ITEM FOR ENVIRONMENTAL COMMISSION AGENDA

NAME & NUMBER OF PROJECT: Concordia University Campus Residence Hall, SP-2020-0038C

REQUEST: Variance request is as follows:
Request to vary from Lake Austin Watershed Ordinance No. 840301-F, Section 9-10-409(b) – for a cut exceeding four feet

STAFF RECOMMENDATION: Staff recommends this variance, having determined the findings of fact to have been met.

CUT-FILL MAP

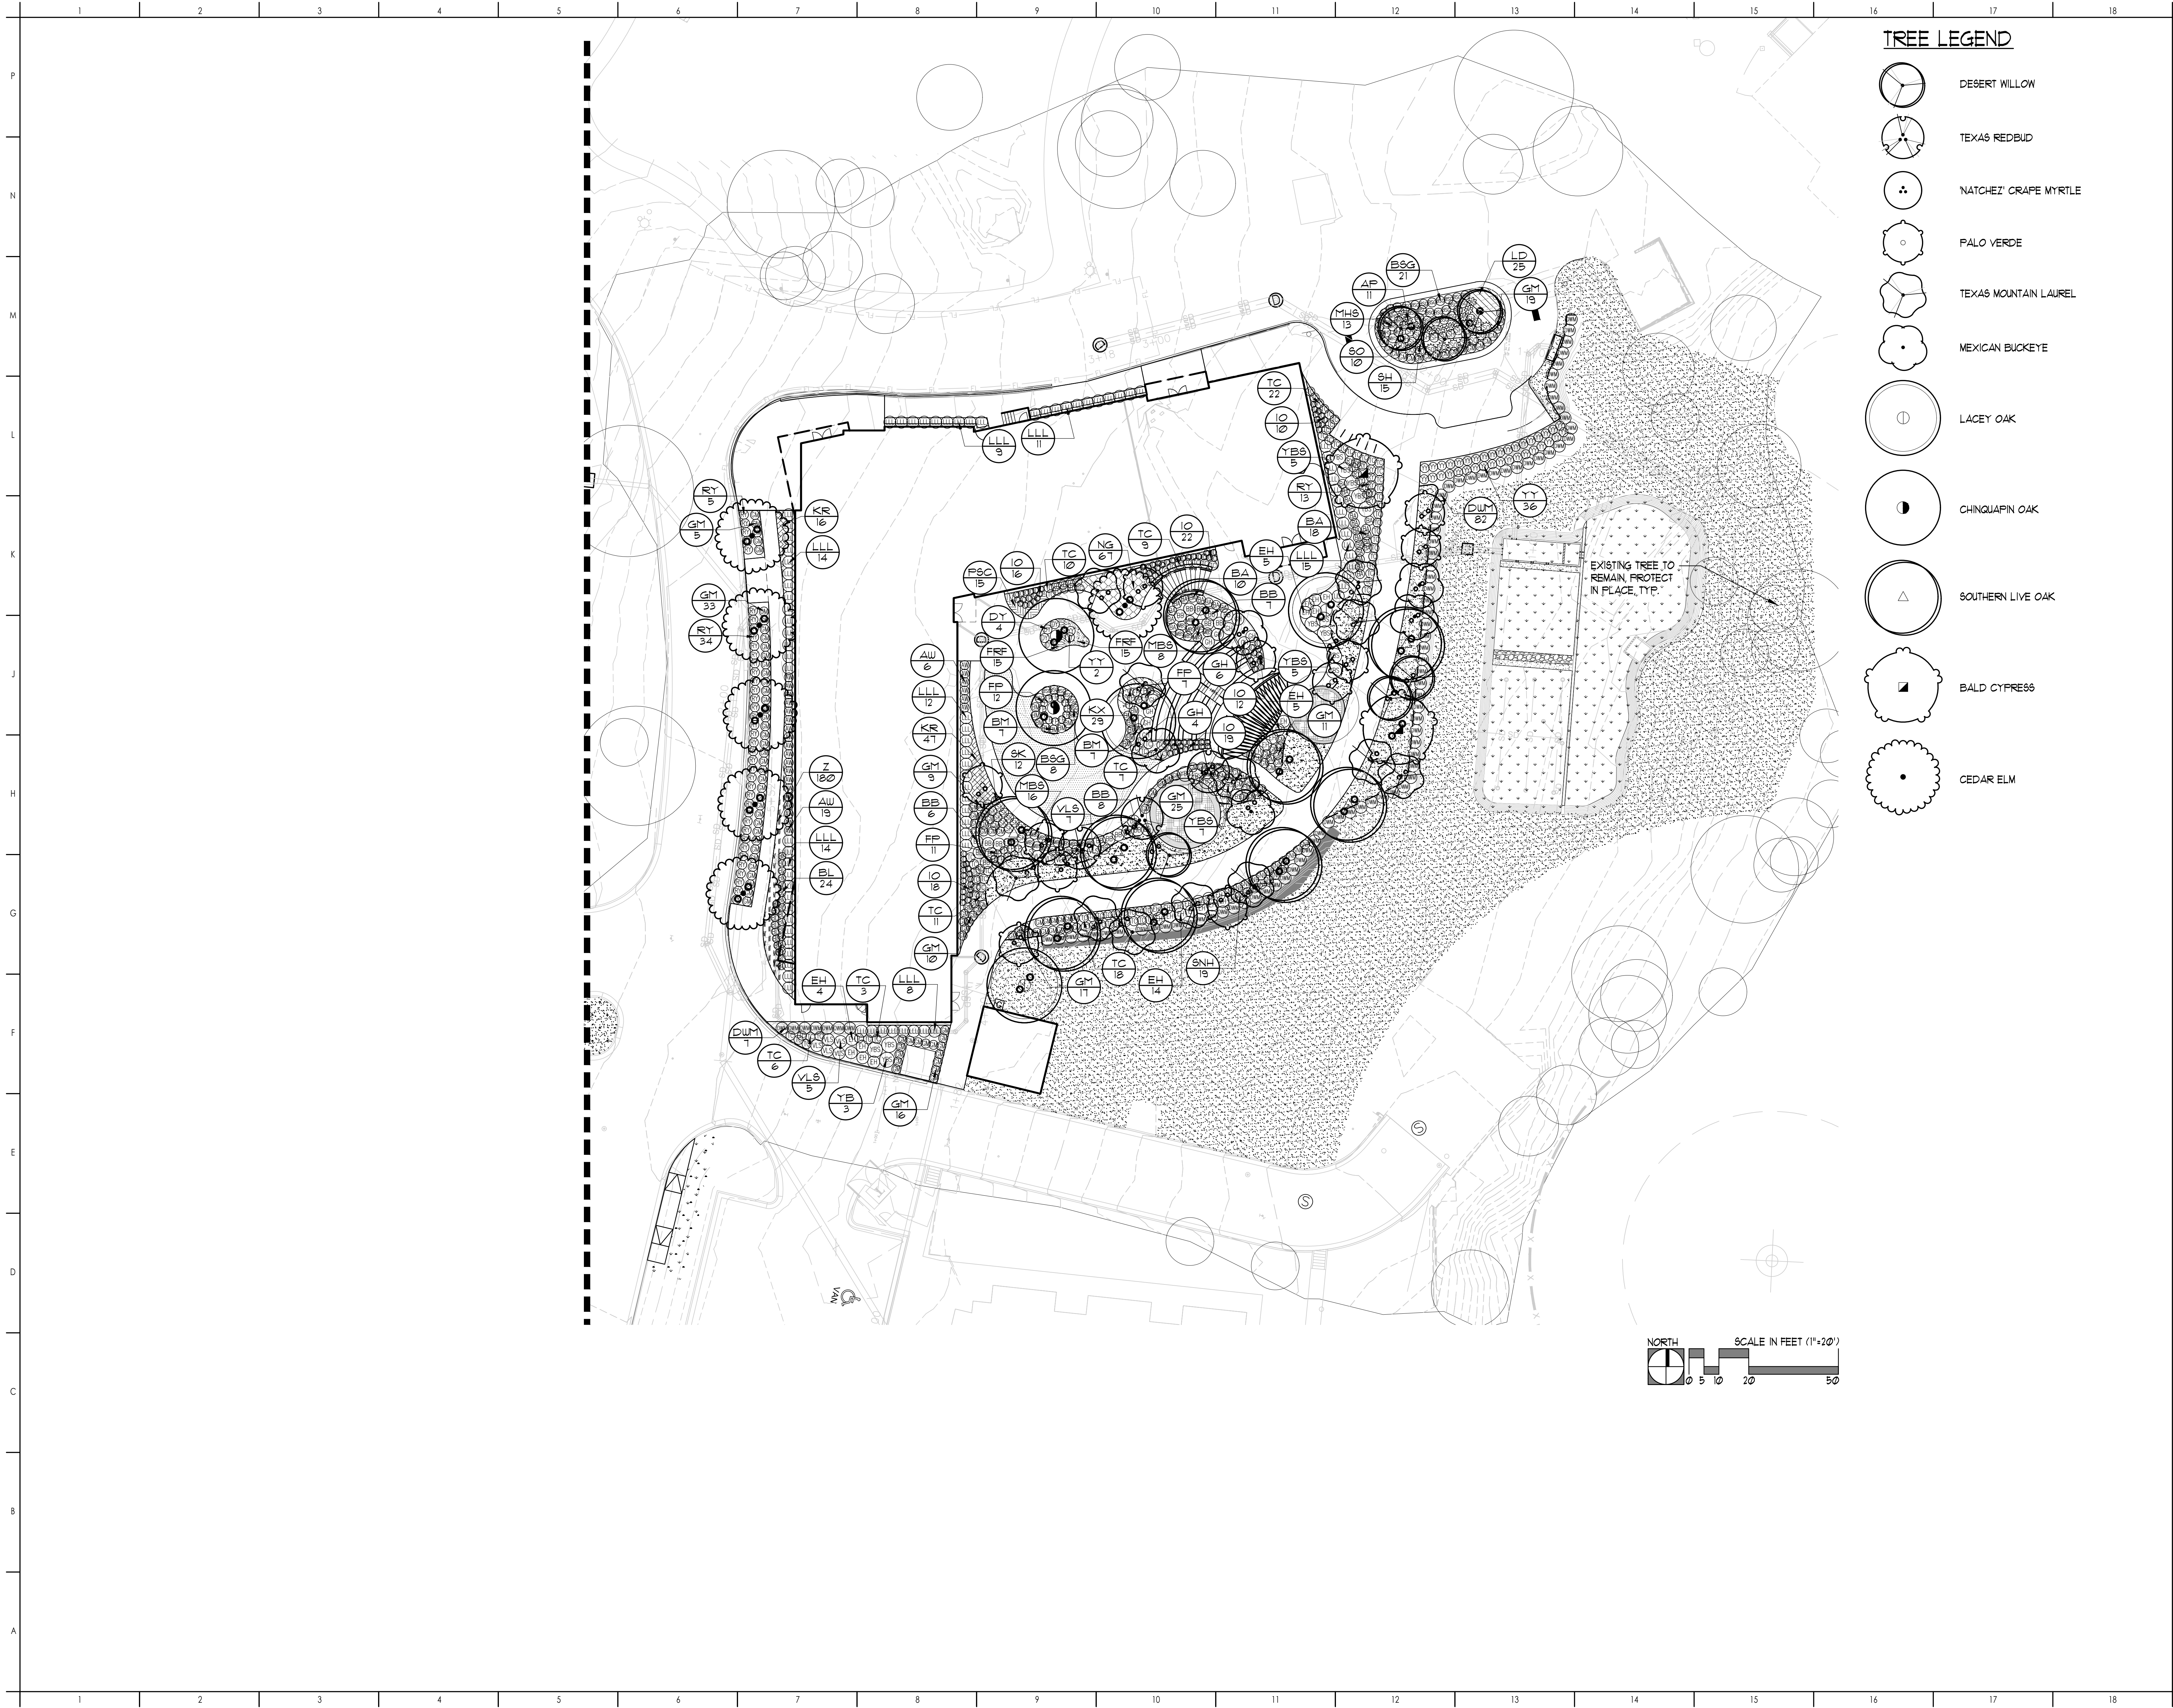
1. Subject to the Void and Water Flow Mitigation Rule (City Environmental Criteria Manual 1.12.0 and City Standards Specification Manual No. 658S) provision that all trenching greater than 5 feet deep must be inspected by a qualified Texas Professional Geoscientist or their representative;
2. Preserve the top 10 inches of topsoil to be used onsite; and
3. Increased tree mitigation and landscaping for areas of fill to stabilize erosion as shown on landscape plan submitted in this variance packet.

1. Subject to the Void and Water Flow Mitigation Rule (City Environmental Criteria Manual 1.12.0 and City Standards Specification Manual No. 658S) provision that all trenching greater than 5 feet deep must be inspected by a qualified Texas Professional Geoscientist or their representative;
2. Preserve the top 10 inches of topsoil to be used onsite; and
3. Increased tree mitigation and landscaping for areas of fill to stabilize erosion as shown on landscape plan submitted in this variance packet.
